**MODIFICATIONS TO
CONTRACT EROSION PREVENTION
AND
SEDIMENT CONTROL (EPSC) PLAN**

HYDE PARK STP CULV (26)

APRIL, 2014

EPSC NARRATIVE AMENDED

EPSC PLAN - PHASE I
 SCALE: 1" = 30'

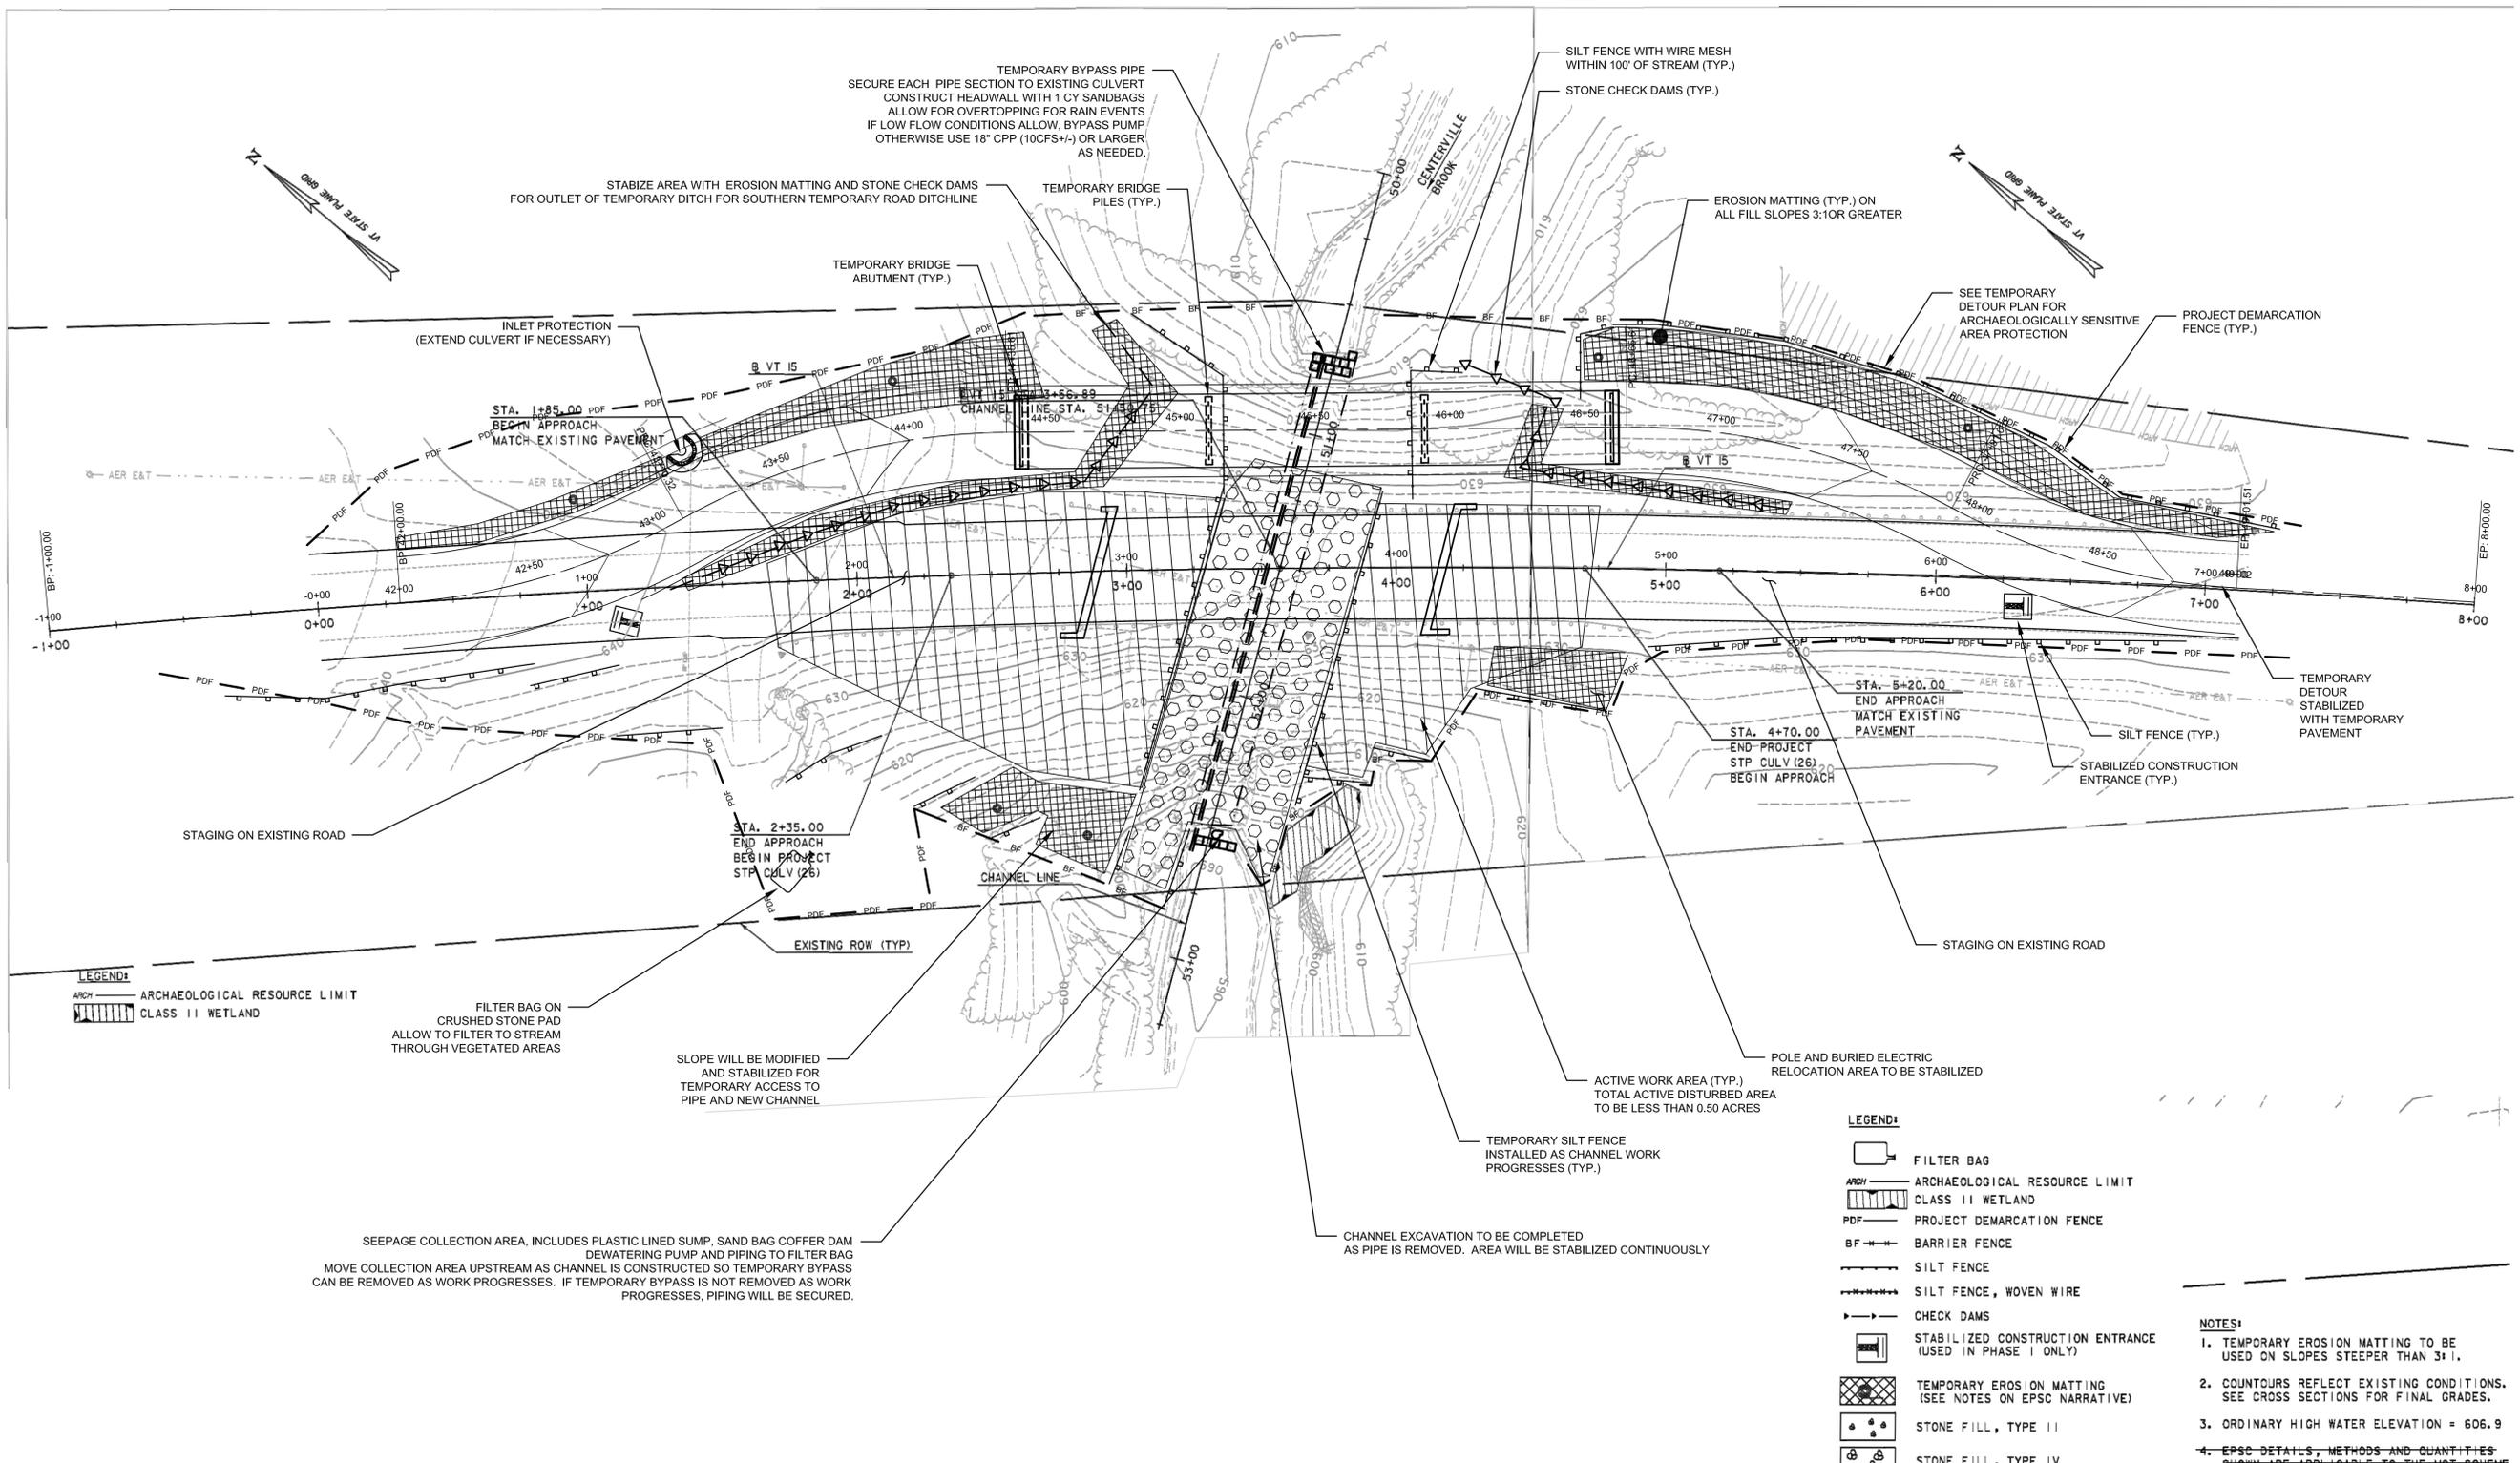
FILTER BAG ON CRUSHED STONE PAD ALLOW TO FILTER TO STREAM THROUGH VEGETATED AREAS

SLOPE WILL BE MODIFIED AND STABILIZED FOR TEMPORARY ACCESS TO PIPE AND NEW CHANNEL

SEEPAGE COLLECTION AREA, INCLUDES PLASTIC LINED SUMP, SAND BAG COFFER DAM DEWATERING PUMP AND PIPING TO FILTER BAG MOVE COLLECTION AREA UPSTREAM AS CHANNEL IS CONSTRUCTED SO TEMPORARY BYPASS CAN BE REMOVED AS WORK PROGRESSES. IF TEMPORARY BYPASS IS NOT REMOVED AS WORK PROGRESSES, PIPING WILL BE SECURED.

TEMPORARY BYPASS PIPE SECURE EACH PIPE SECTION TO EXISTING CULVERT CONSTRUCT HEADWALL WITH 1 CY SANDBAGS ALLOW FOR OVERTOPPING FOR RAIN EVENTS IF LOW FLOW CONDITIONS ALLOW, BYPASS PUMP OTHERWISE USE 18" CPP (10GFS+) OR LARGER AS NEEDED.

STABILIZE AREA WITH EROSION MATTING AND STONE CHECK DAMS FOR OUTLET OF TEMPORARY DITCH FOR SOUTHERN TEMPORARY ROAD DITCHLINE

CHANNEL EXCAVATION TO BE COMPLETED AS PIPE IS REMOVED. AREA WILL BE STABILIZED CONTINUOUSLY

EPSC PLAN - PHASE 2
 SCALE: 1" = 30'

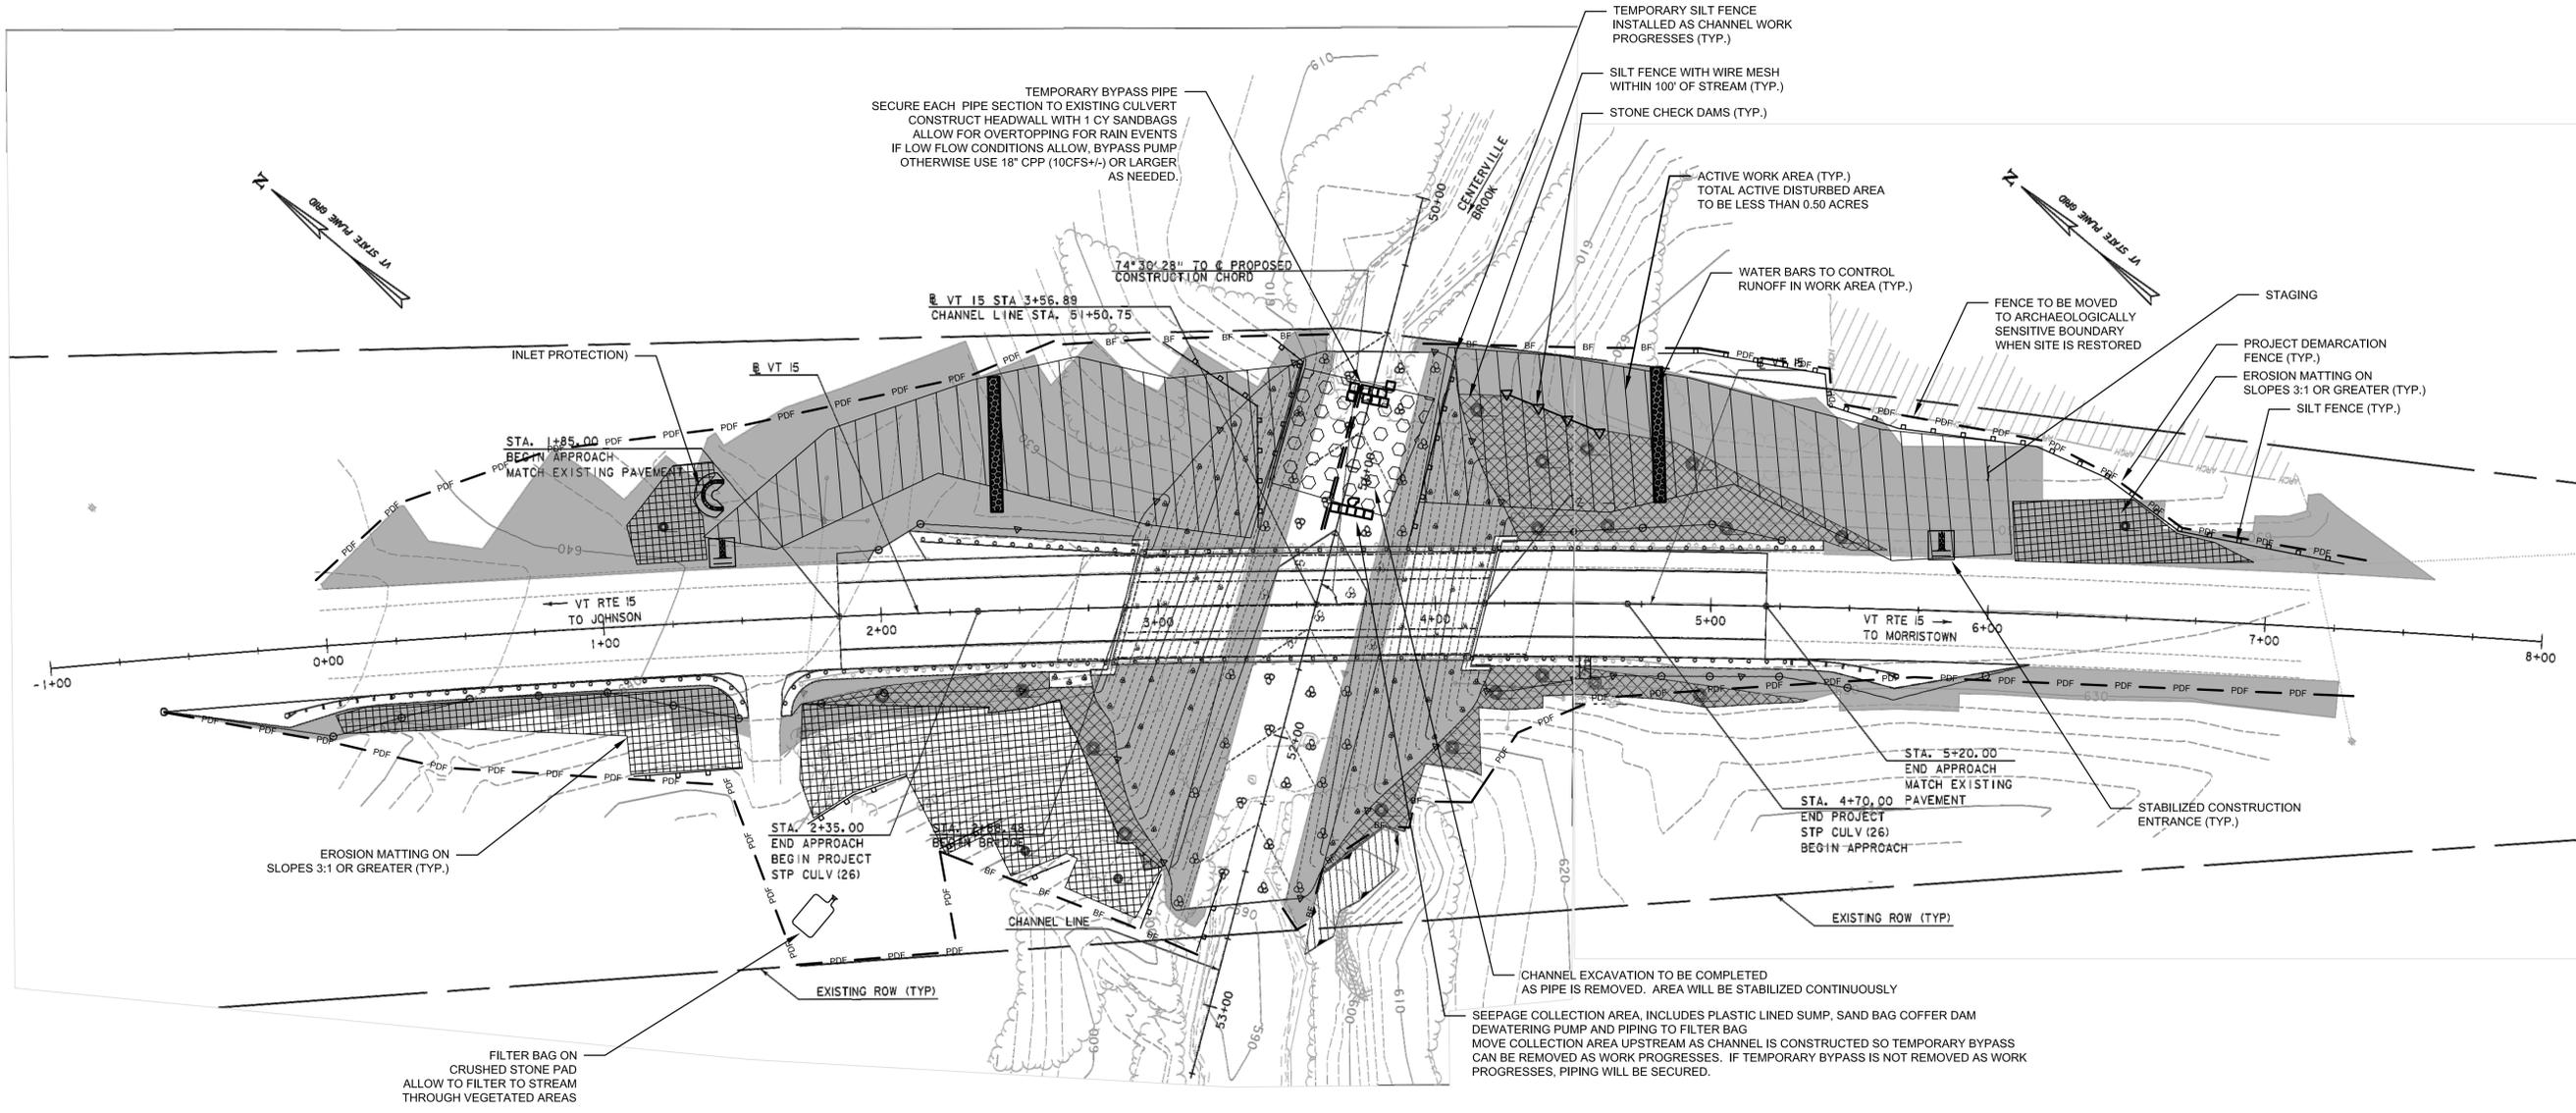
The last remaining sections of the culvert will be removed. Temporary bypass will be used again to control stream flow through the work area. Seepage dewatering will be collected again and pumped to a filter bag on the southwestern area of the project.

EPSC PLAN - PHASE 3
 SCALE: 1" = 30'

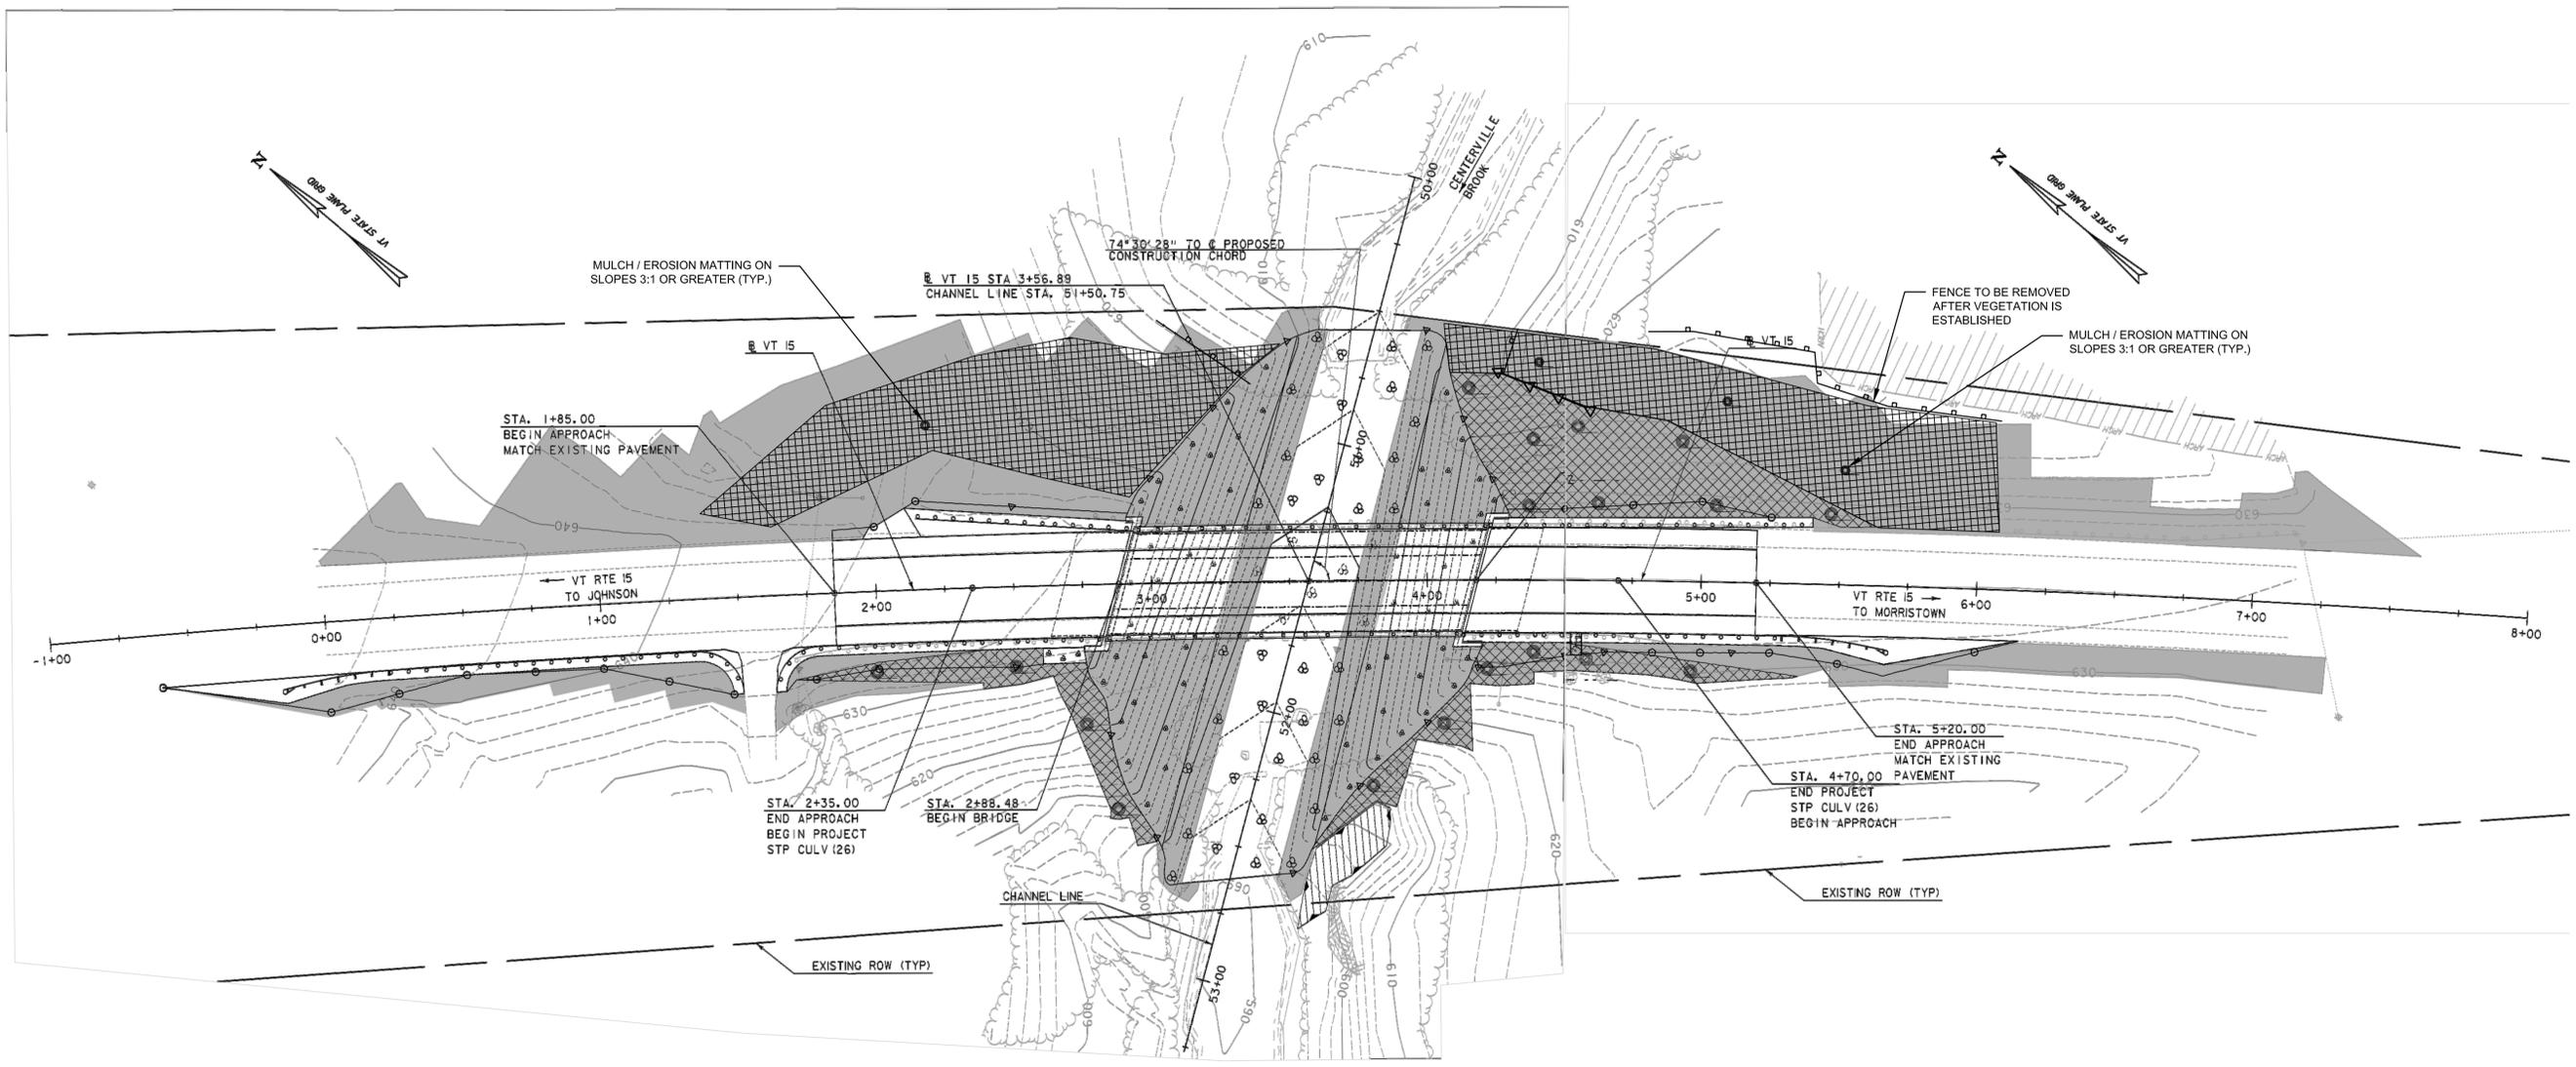
The work area will be restored to final stabilization working away from the culvert work area. The dewatering access and site area will be returned to finish grade and final stabilization measures will be installed, including erosion matting. Silt fence will remain until vegetation has been established on the site. Once the site is stable, all structural measures will be removed and property disposed.
